Tollway Standard Drawing Revisions

Standard	
	Modification Summary Effective: 03/31/14
C1	Galvanized Steel Plate Beam Guardrail
Sheet 2	Removed Secondary Hole In Post
	Revised Table 2, Removed Desirable Barrier Clearance Distance
C2	Reserved
	Median Pier Protection Standard has been Retired
C3	Single Face Reinforced Concrete Barrier
	Redesign for TL-4 Loading
	Widen Base Slab for Slip Forming; Continuous 2'-0" Gutter
C4	Concrete Shoulder Barrier Transition
	Redesign for TL-4 Loading
	Widen Base Slab for Slip Forming; Continuous 2'-0" Gutter
C5	Concrete Barrier Base and Concrete Barrier Double Face 42"
	Widen Base Slab for Slip Forming; Continuous 2'-0" Gutter
	Removed Tie Bars
	Increased Number of Conduits in Base
	Increased Number of Conduits in base
C6	Traffic Barrier Terminal Type T1 (Special)
	Revised Recovery Area Dimension; Added 5' In Advance of Terminal End
C 7	Traffic Barrier Terminal Type T2
	Revised Note 5
C8	Reserved
	Traffic Barrier Terminal Type T5 has been retired

STANDARD C1-07

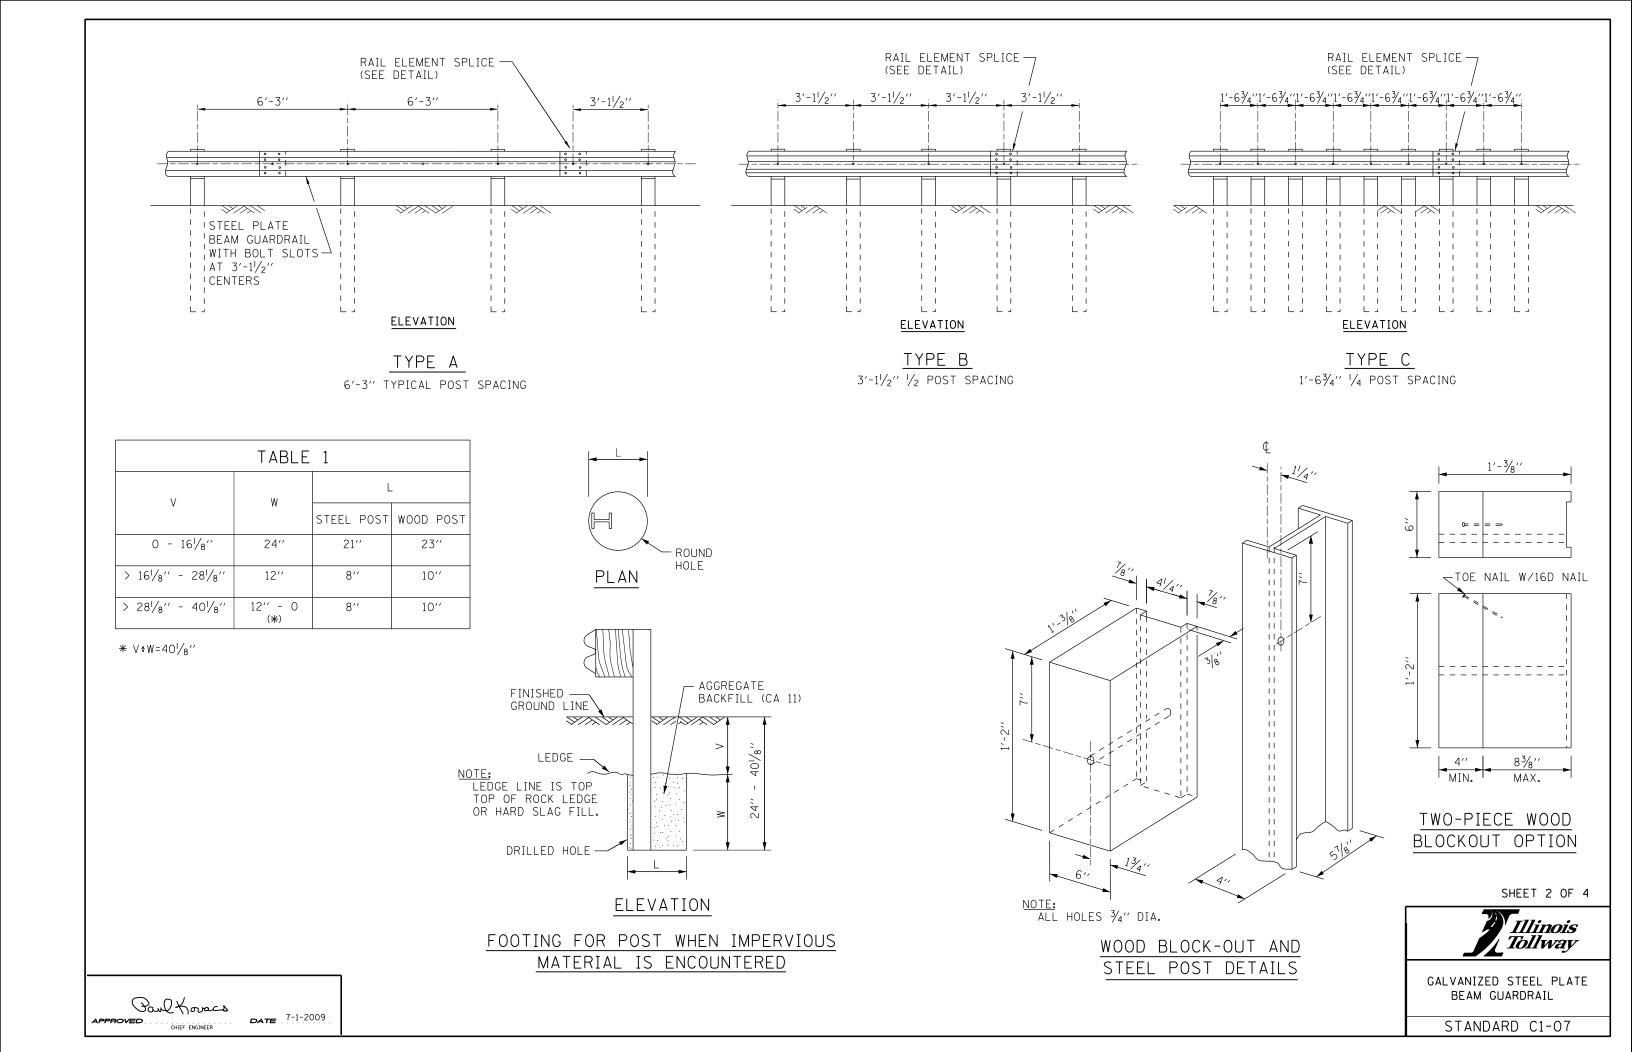
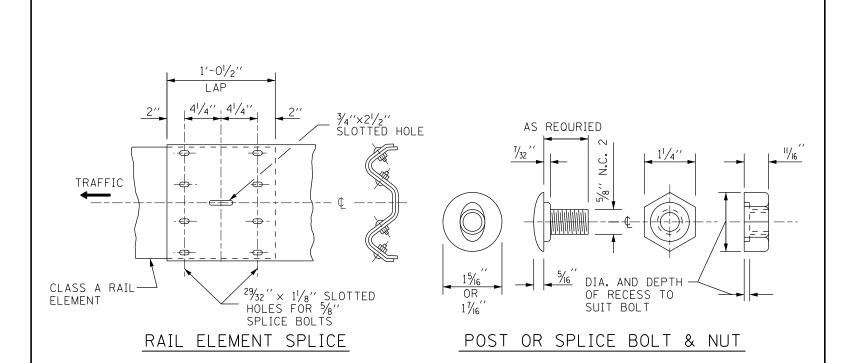
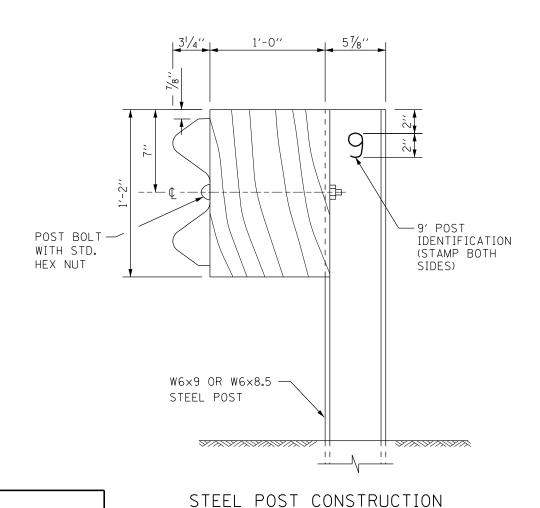
3-31-2014 REMOVED SECONDARY HOLE FROM POST AND UPDATED NOTES.

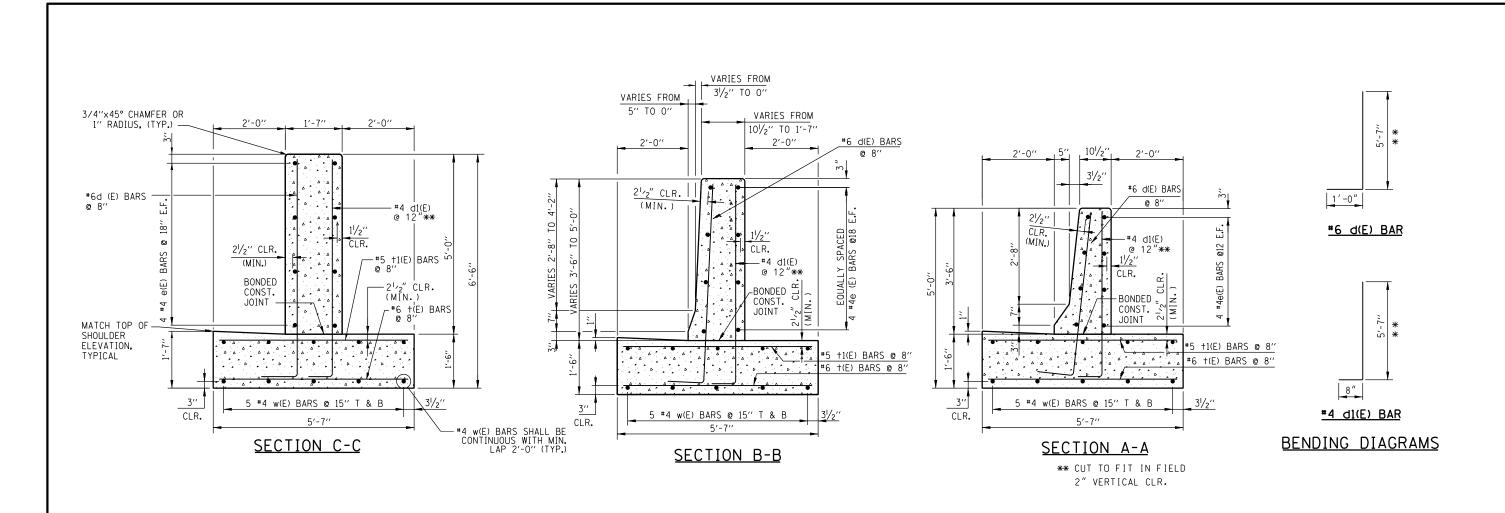
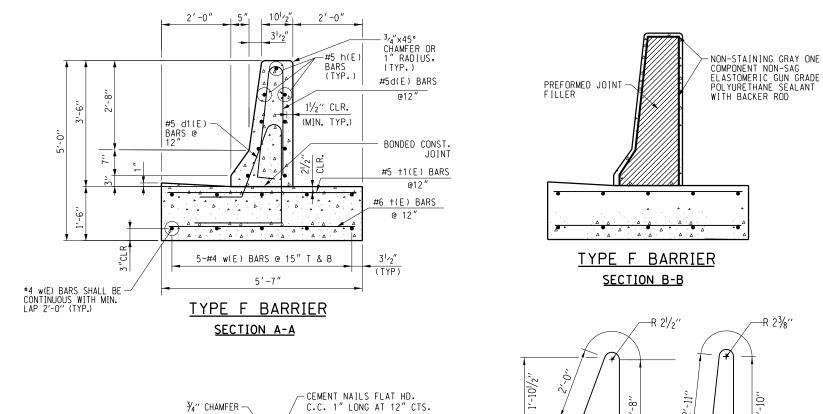
DATE	REVISIONS	Illinois Tollway
2-7-2012	DELETED TYPE II BARRIER AND	
	REVISED REINFORCEMENT BARS	611101 E ELOE BEILIEGBOED
11-1-2012	GUTTER TRANSITION TAPER DETAIL	SINGLE FACE REINFORCED
	NEW JOINT DETAIL, REVISED NOTES	CONCRETE BARRIER
10-1-2013	REVISED REINFORCEMENT BARS, AND	
	GUTTER WIDTH	
3-31-2014	REDESIGNED FOR TL-4 LOADING	STANDARD C3-04
		STANDARD CJ-04

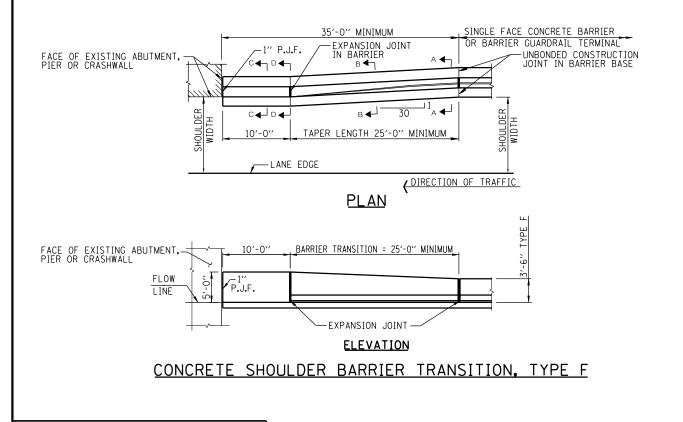
DATE	REVISIONS	N Illinois
2-7-2012	DELETED SHOULDER BARRIER TRANSITION TYPE II, TAPER CHART, REVISED REINFMNT. BARS AND REVISED LENGTH	Tollway
11-1-2012	OF VERTICAL FACE BARRIER WALL. INCREASED BARRIER TRASITION, NEW JOINT DETAIL REVISED REBARS, REBAR LOCATIONS, BARRIER BASE THICKNESS AND NOTES	CONCRETE SHOULDER BARRIER TRANSITION
3-31-2014	REDESIGNED FOR TL-4 LOADING	STANDARD C4-04

TRAFFIC BARRIER TERMINAL, TYPE T6B STANDARD C10-05

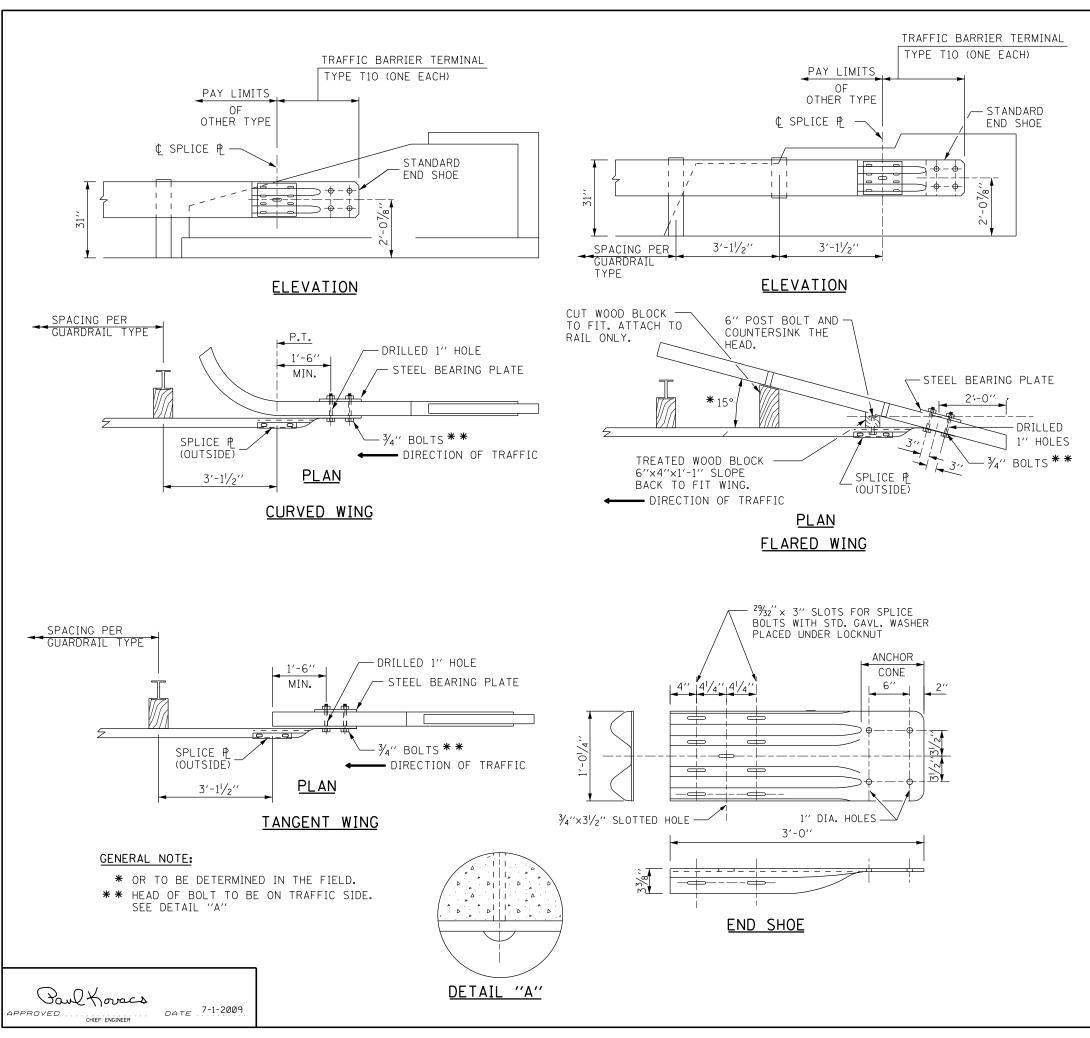
Replaced With Traffic Barrier Terminal Type T10
C9	Traffic Barrier Terminal Type T6
	Revised Note 7
C10	Traffic Barrier Terminal Type T6B
010	Revised Depth of Blockouts A-B-C-D To 1'-6"
C11	Troffic Possics Toyming Type T40
	Traffic Barrier Terminal Type T10 Revised Note 4
	Revised Note 4
C12	Traffic Barrier Terminal Type T1-A (Special)
	Revised Recovery Area Dimension; Added 5' In Advance of Terminal End
C13	Concrete Median Barrier Transition Type V-F at Bridge Piers
	Widen Base Slab for Slip Forming; Continuous 2'-0" Gutter
	Removed Tie Bars
1	Out and a Barrier Transition Transition Transition Plans
C14	Concrete Barrier Transition, Type V at Biridge Piers

MODIFIED THICKNESS DETAIL WOOD BLOCKOUTS A, B, C, & D
